Groundwater Transfer Review Summary Form

Transfer/PA # T- 14575

Application: T-14575

Applicant Name: Arita Volker

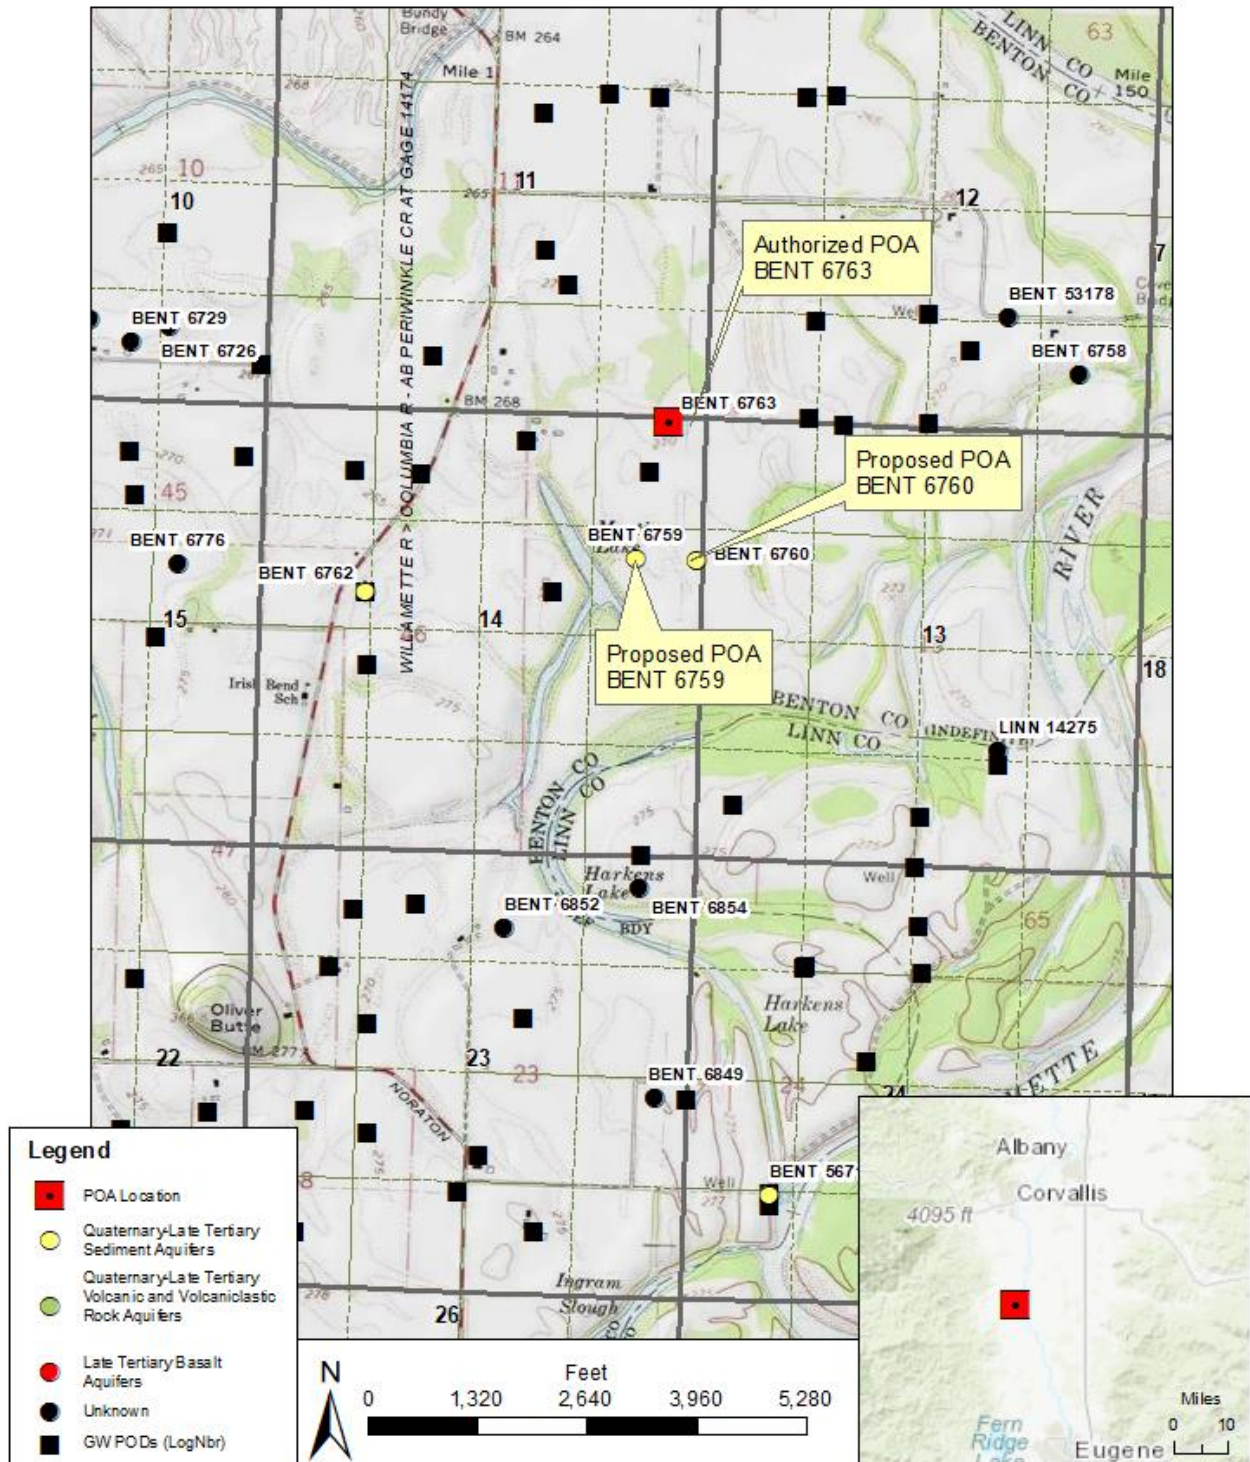
- Certificate 46854:
 - Authorized PODs: POD 1 and POD 2
 - Proposed APOD: POD 3
- Certificate 48426:
 - Authorized POA: BENT 6763 (Home Place Well)
 - Proposed APOAs: Bent 6759 (Proposed Well 1) and BENT 6760 (Proposed Well 2)

2. Will the proposed POA develop the same aquifer (source) as the existing authorized POA?
☒ Yes ☐ No Comments: The existing POA (BENT 6763) and the proposed additional POA (BENT 6579 and 6760) are all completed in the shallow alluvial aquifer (sand and gravels).

5. a) Will this proposed change, at its maximum allowed rate of use, likely result in an increase in interference with **another ground water right**?
☐ Yes ☒ No Comments: All POAs indicated on this application are similar distances to other groundwater POAs.

6. a) Will this proposed change, at its maximum allowed rate of use, likely result in an increase in interference with **another surface water source**?
☐ Yes ☒ No Comments: Despite the proposed additional POAs being closer to Martins Lake, all the surface water bodies are part of the same Water Availability Basin (WAB), which is the Willamette R > Columbia R – AB Periwinkle CR at Gage 14174. Therefore, any potential shift of depletion from the Long Tom River to the Willamette River will not affect the overall surface water availability.
